COUNCIL ASSESSMENT PANEL

Meeting Agenda

3.1 1-7 Cairns Street, Adelaide [Pages 4 - 27]

3.2 42 Melbourne Street, North Adelaide [Pages 28 - 60]

Figure 8.5.2 – comparison of proposal to 45-degree plane requirement

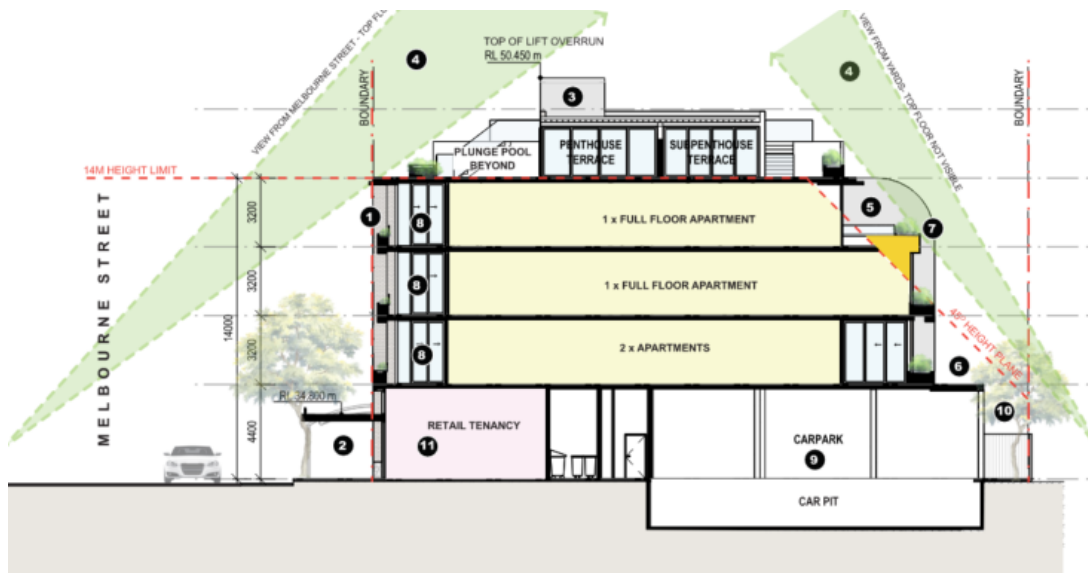
The proposal largely achieves the relevant /DPF provisions, except for relatively minor encroachments indicated in Figure 8.5.2.

The extent of built form outside of the 45-degree building envelope includes balconies and planters. Whilst there is a portion of the building that does not meet the 45-degree plane, most of the built form does sit within the envelope and importantly the floor area located on the level above the maximum height is within the envelope.
